HISTORIC AND DESIGN REVIEW COMMISSION

HDRC CASE NO: 2016-097
ADDRESS: 3700 N ST MARYS
ZONING: R6 HS RIO-1
CITY COUNCIL DIST.: 2
LANDMARK: Brackenridge Park
APPLICANT: Stan Albus/Rialto Studio, Inc
OWNER: City of San Antonio Parks and Recreation Department
TYPE OF WORK: Repair and maintenance to park entrance monuments, sculptures and restroom buildings

Re: **Brackenridge Park 2012 Bond Package**

2 TULETA AVENUE @ BROADWAY

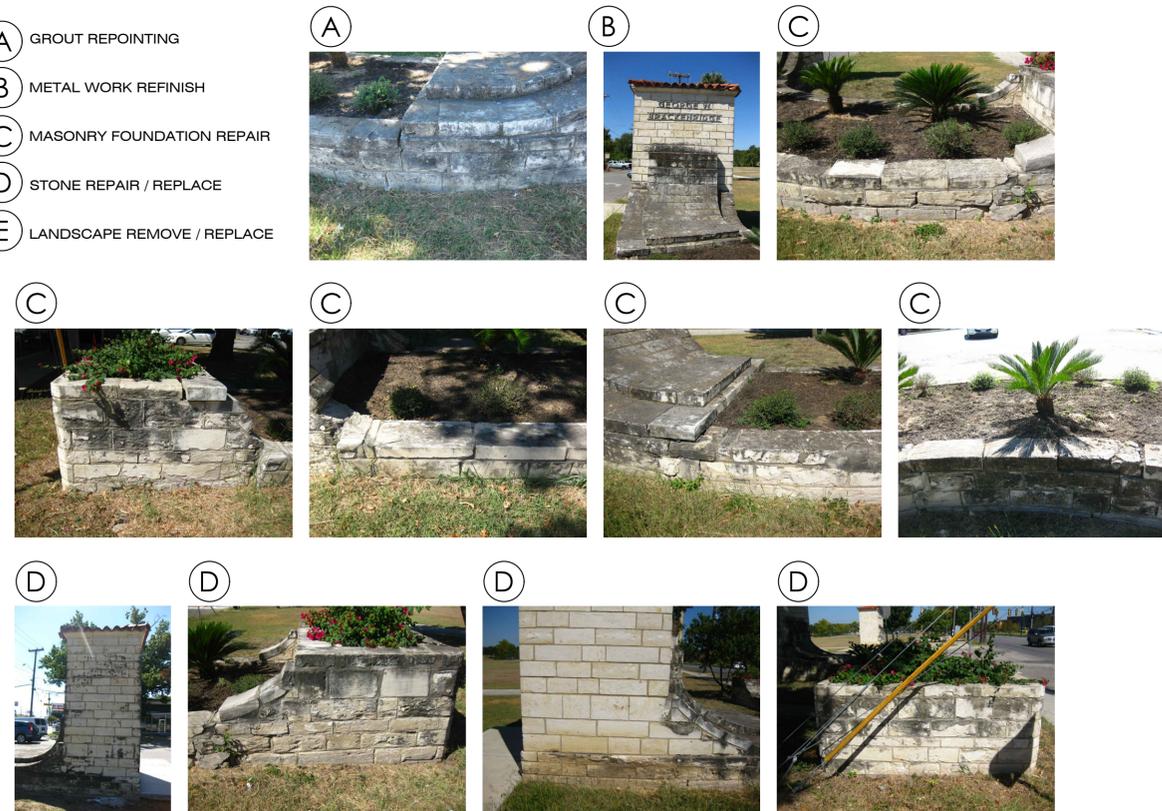
GENERAL RESTORATION NEEDED:

- (A) GROUT REPOINTING
- (B) METAL WORK REFINISH
- (C) MASONRY FOUNDATION REPAIR
- (D) STONE REPAIR / REPLACE
- (E) LANDSCAPE REMOVE / REPLACE

1 PALAPA BENCH

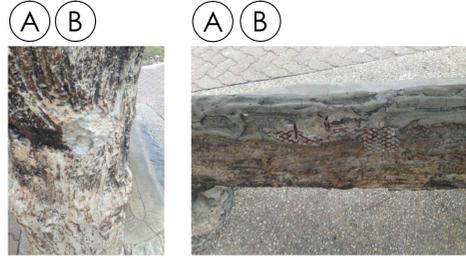
GENERAL RESTORATION NEEDED:

- (A) COSMETIC REPAIRS
- (B) VENEER FINISH REFRESHING

2 HOLLOW TREE BENCH

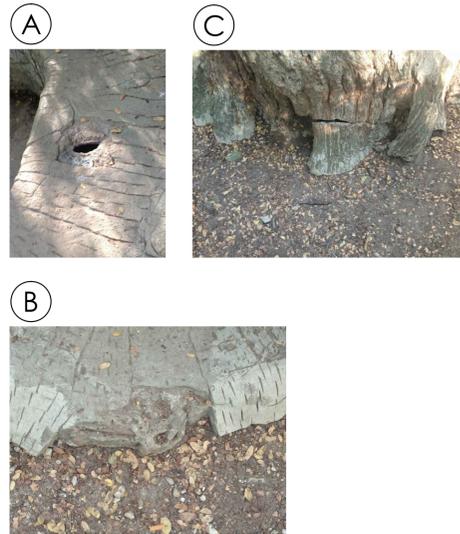
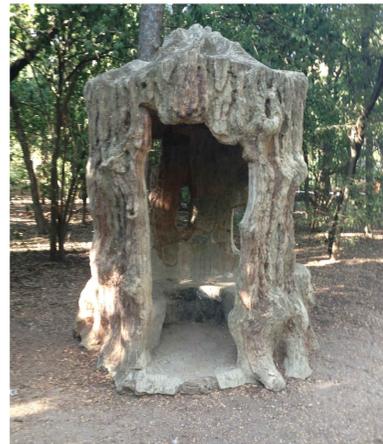
GENERAL RESTORATION NEEDED:

- (A) COSMETIC REPAIRS
- (B) VENEER FINISH REFRESHING
- (C) MINOR STRUCTURAL REPAIRS

3 PALAPA TABLE

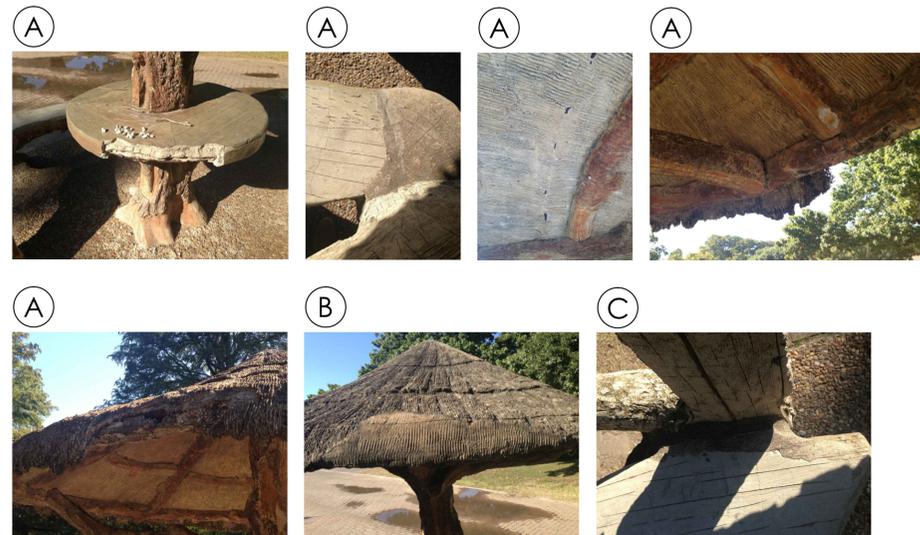
GENERAL RESTORATION NEEDED:

- (A) COSMETIC REPAIRS
- (B) VENEER FINISH REFRESHING
- (C) MINOR STRUCTURAL REPAIRS

4 BRIDGE

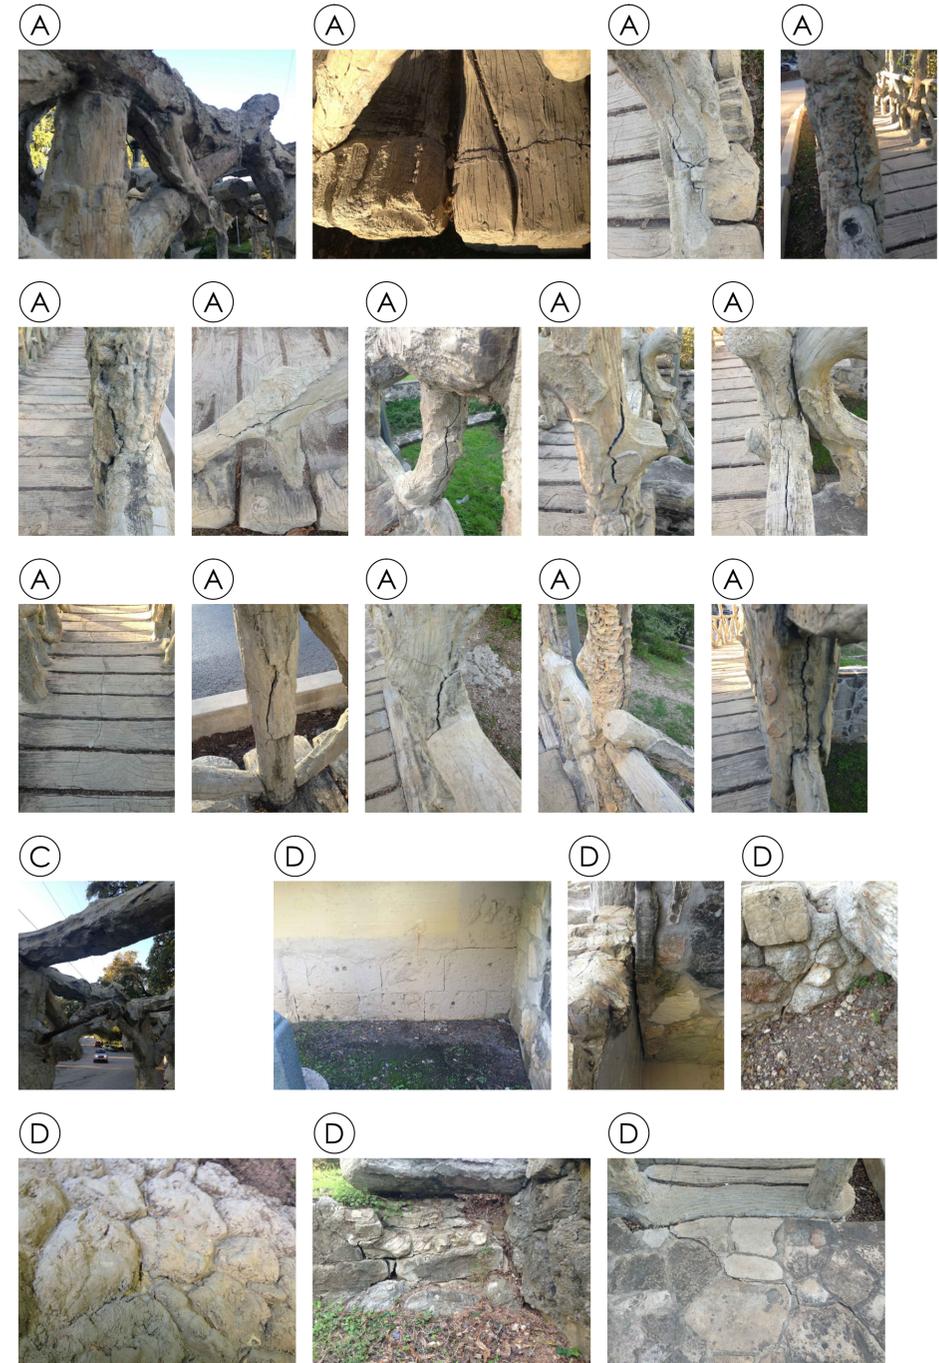
GENERAL RESTORATION NEEDED:

- (A) COSMETIC REPAIRS
- (B) VENEER FINISH REFRESHING
- (C) MINOR STRUCTURAL REPAIRS
- (D) MAJOR STRUCTURAL REPAIRS

1 EXISTING EXTERIOR ELEVATIONS

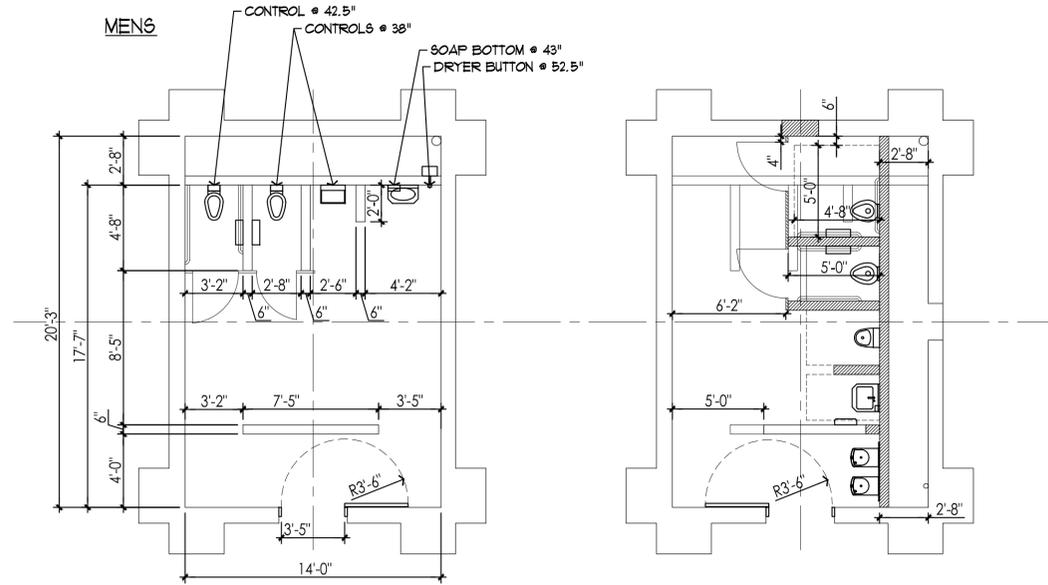
- EXISTING CONDITION:
- WATER CLOSET AND URINAL SPACES ARE NOT COMPLIANT
 - HEIGHTS OF CONTROLS ARE NOT COMPLIANT
 - SINK IS NOT COMPLIANT
 - OTHER ACCESSORIES NOT COMPLIANT
 - EXIT LANDING MAY NOT BE COMPLIANT

- OPTION 3:
- GUT COMPLETE INTERIOR, CLOSE CHASE ACCESS
 - CREATE NEW PLUMBING CHASE WITH IMPROVED ACCESS
 - MODIFY ENTRANCE
 - INSTALL NEW FIXTURES THROUGHOUT
 - ADDRESS PAYING ISSUES
 - ALLOWS SPACE FOR DRINKING FOUNTAIN

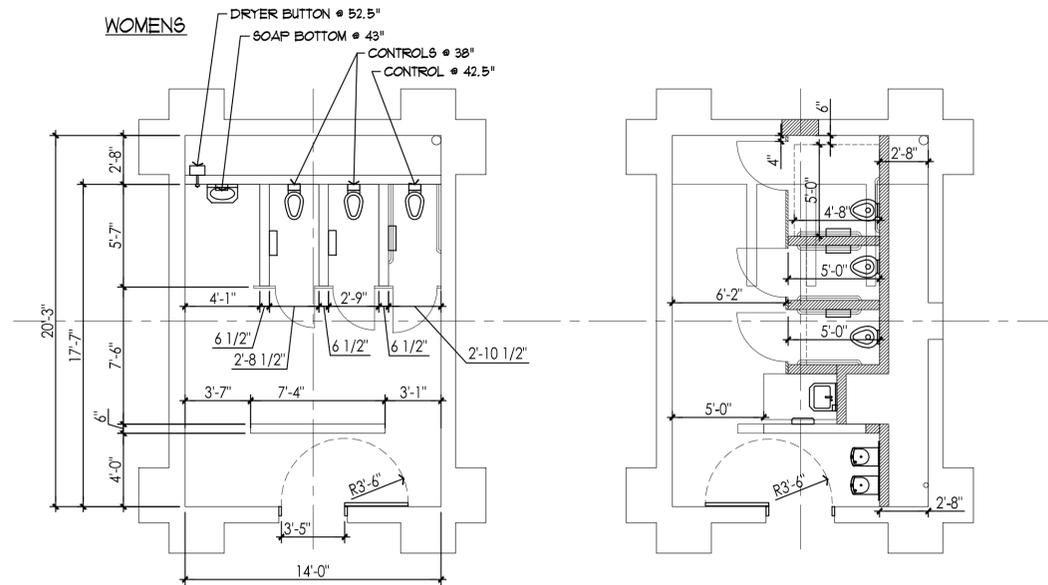
- EXISTING CONDITION:
- WATER CLOSET SPACES ARE NOT COMPLIANT
 - HEIGHTS OF CONTROLS ARE NOT COMPLIANT
 - SINK IS NOT COMPLIANT
 - OTHER ACCESSORIES NOT COMPLIANT

- OPTION 3:
- SIMILAR TO MEN'S
